January 30, 2009

J. Mike Monasmith  
Siting Project Manager  
California Energy Commission  
1516 Ninth Street, MS-15  
Sacramento, CA 95814

**Re: Carlsbad Energy Center Project (07-AFC-6)**  
**Applicant's Comments to Preliminary Staff Assessment**

## FIGURE A-2

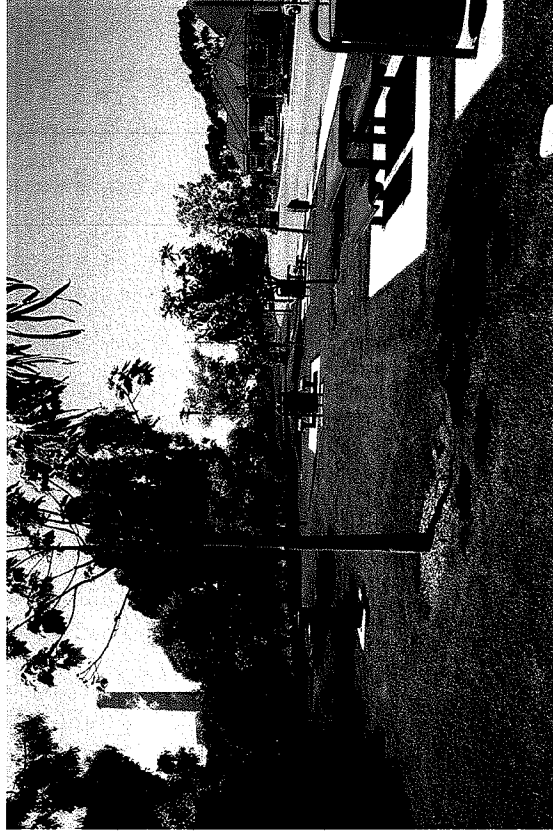
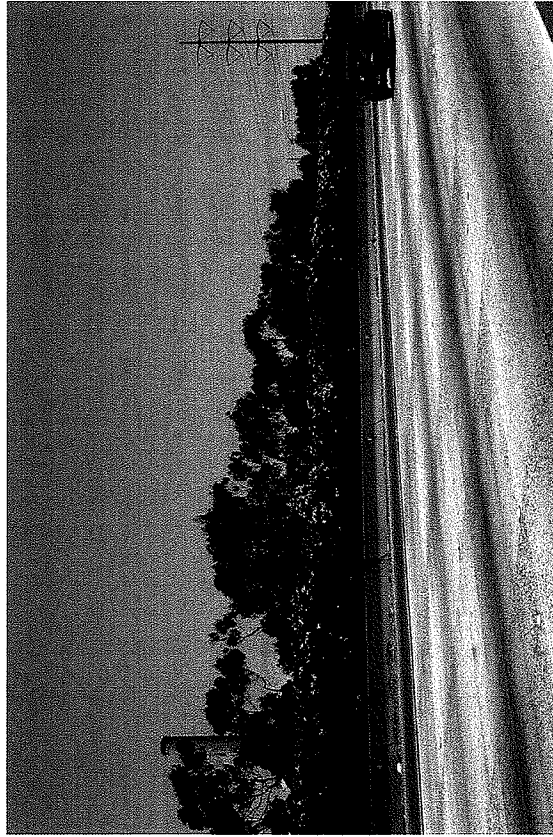
Photo A-1 is a view from Cannon Boulevard, west of the site. From this location the concrete block perimeter wall of the existing SDG&E site and mature trees located along Cannon Road and on the power plant site screen views toward the proposed switchyard. Photo A-2, taken from the park located on Cannon Road at Avenida Encinas, includes the existing EPS stack, seen beyond existing vegetation at the left side of the photo. From this location, the new substation will be screened by vegetation and buildings which are located across Avenida Encinas, seen on the right side of the photo. Photo A-3 is a view from northbound on Interstate 5 looking northwest toward the switchyard site. Although a split second, partial view of the new switchyard may be available from northbound Interstate 5, mature trees to the west of the roadway as well as by tall shrubs in the Interstate 5 median will generally screen views of the new switchyard structures. Photo A-4, a view along Cannon Road from the roadside fruit stand, encompasses low agricultural fields and overhead transmission lines supported on steel poles in the foreground. The existing EPS and transmission lines appear prominently in the background and the middleground, respectively, in this view from about a quarter mile east of the switchyard site.

**FIGURE A-3**  
**NEW SDG&E 230kV SWITCHYARD**  
**EXISTING VIEW AND VISUAL SIMULATION**  
CARLSBAD ENERGY CENTER PROJECT

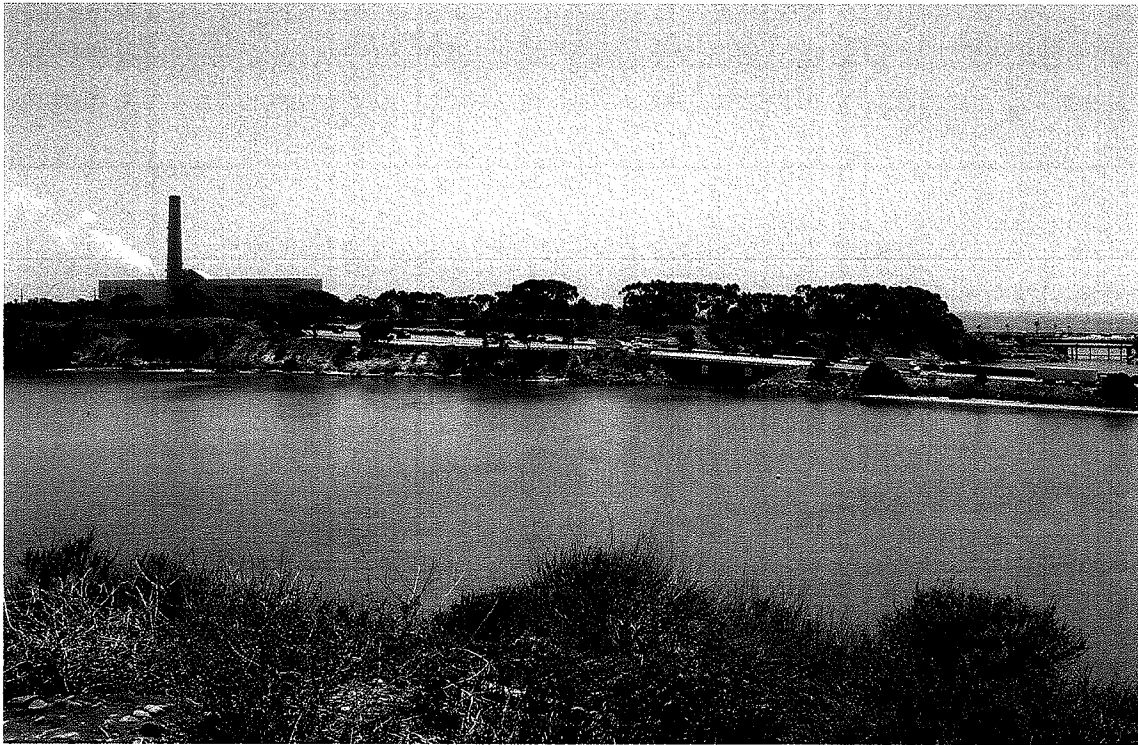
Figure A-3 presents a before and after view of the new 230kV switchyard as seen from this Cannon Road vantage point (A-4). This simulation shows portions of the new switchyard on the left side of the view with the existing transmission towers in the center and on the right. Vegetation to the west of Interstate 5 partially screens lower portions of the switchyard and new transmission towers. The simulation demonstrates that where the new 230kV switchyard will appear against a backdrop of the existing EPS, it will barely be visible. Other portions of the new 230kV switchyard will be visible against the sky; however, given the presence of existing structures, the new elements will not be particularly noticeable. A comparison of the before and after images demonstrates that the new 230kV switchyard will not be particularly noticeable

**FIGURE 1**  
**ADAMS STREET**  
**EXISTING VIEW AND VISUAL SIMULATION**

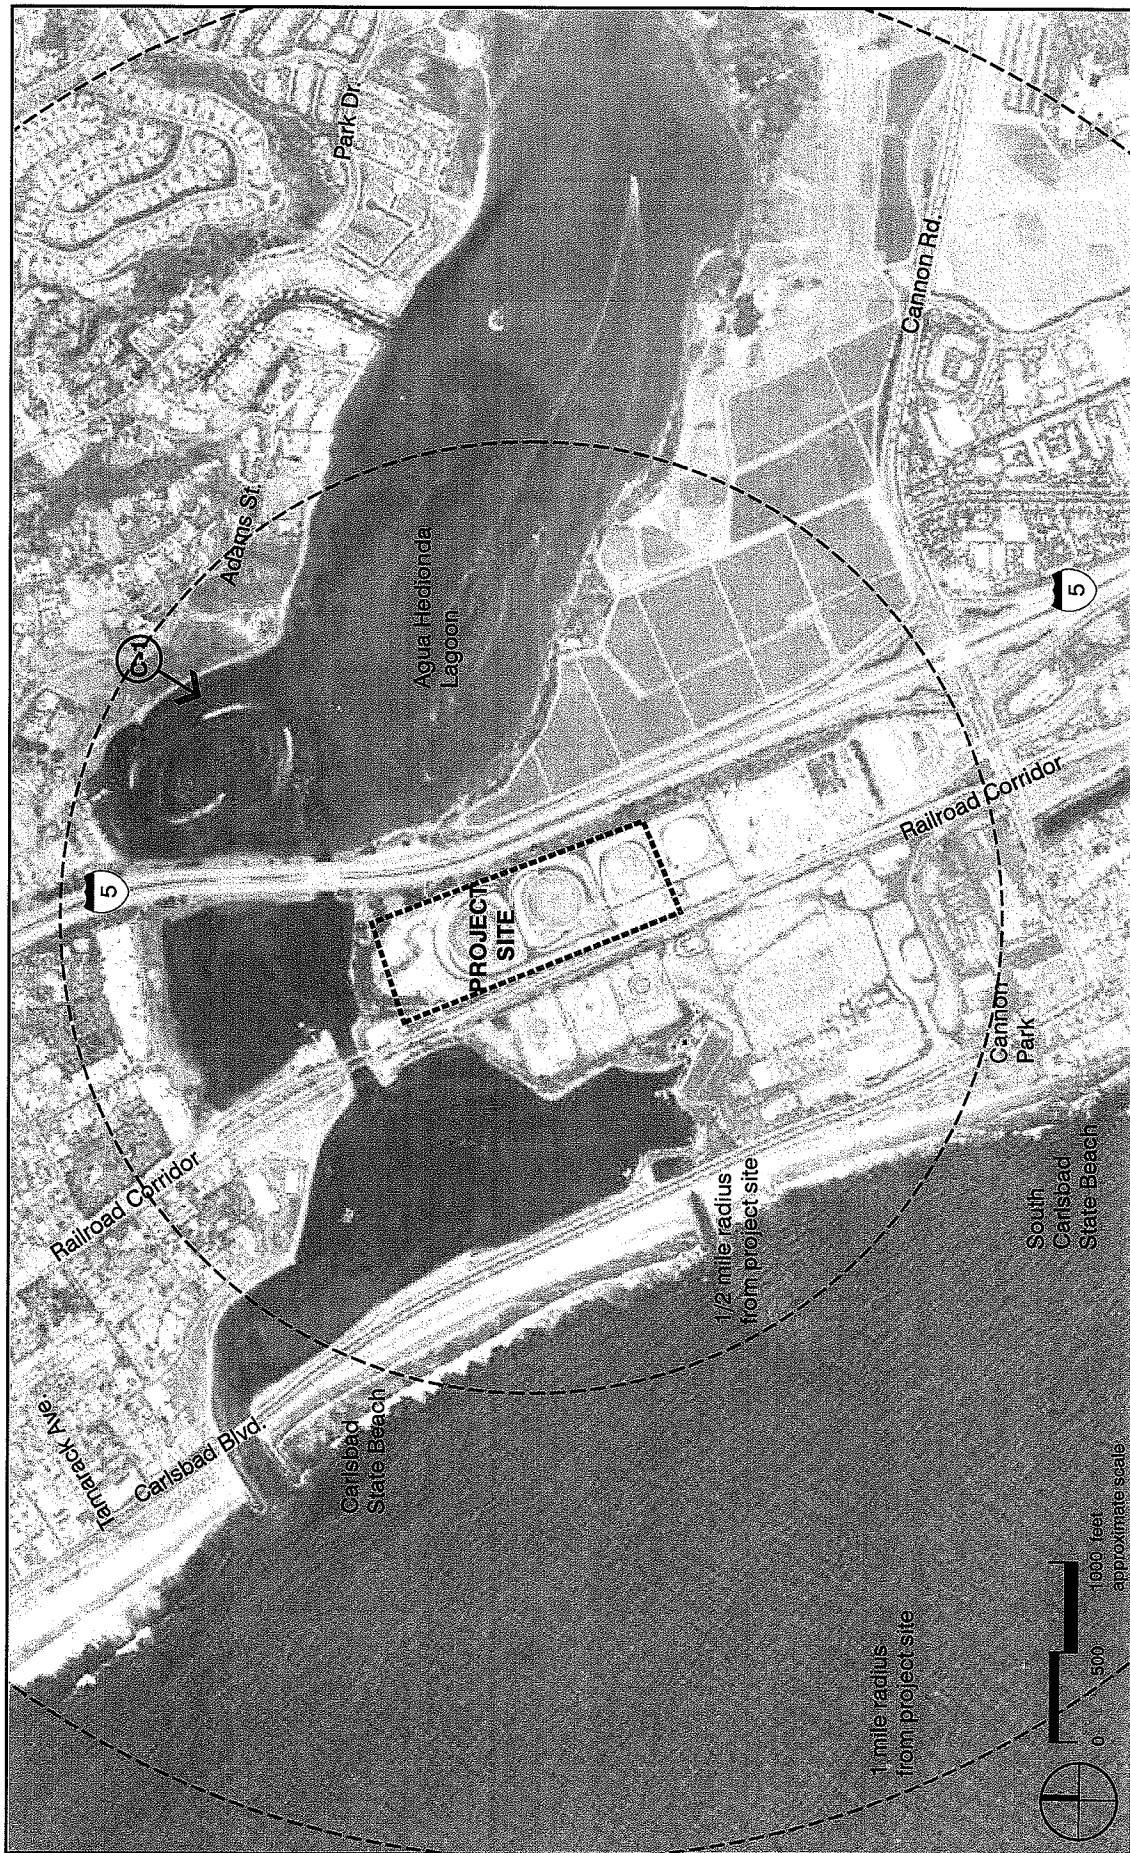
New Figure 1 is an accurate computer-generated visual simulation showing the appearance of Applicant from a vantage point along Adams Street near Hoover Street looking southwest. The “before” and “after” image correctly portray the site and the appearance and scale of CECP from a known public vantage point, delineated on Figure 2. The simulation demonstrates that the existing EPS structures appear prominently and, when seen within this context, portions of CECP, including the new stacks, will appear in close proximity to the larger existing facility.

The Figure 1 photo was shot in June 2007 using a single lens reflex (SLR) digital camera with a 50 mm lens equivalent that captures a horizontal view angle of 40 degrees. Global positioning system (GPS) technology and aerial photo basemap recording was employed to document the photo viewpoint location. A brief description of the computer modeling and technical procedures used to produce this accurate simulation image are outlined below.

Existing topographic and site data provided the basis for developing an initial digital site model. CECP engineers provided site plans and digital data for the proposed facility and existing structure removal. These were used to create a three dimensional digital model of the proposed facility. This model was combined with the digital site model to produce a computer model of the Project. Viewer location was entered from GPS data and scaled aerial photos, using 5 feet as the assumed eye level. A computer “wire frame” perspective plot was then overlaid on the photograph to verify scale and viewpoint location. The digital visual simulation image was then produced based on computer renderings of the 3-D model combined with digital versions of the selected site photographs. The final “hardcopy” visual simulation image has been printed from the digital image files and produced in color on an 11 by 17 inch sheet. The images are presented at a size that is approximately 9 inches in width. These “before” and “after” images should be viewed at a distance of approximately 12.5 inches to gain an optimal impression of the Project’s scale in relationship to the surrounding landscape.
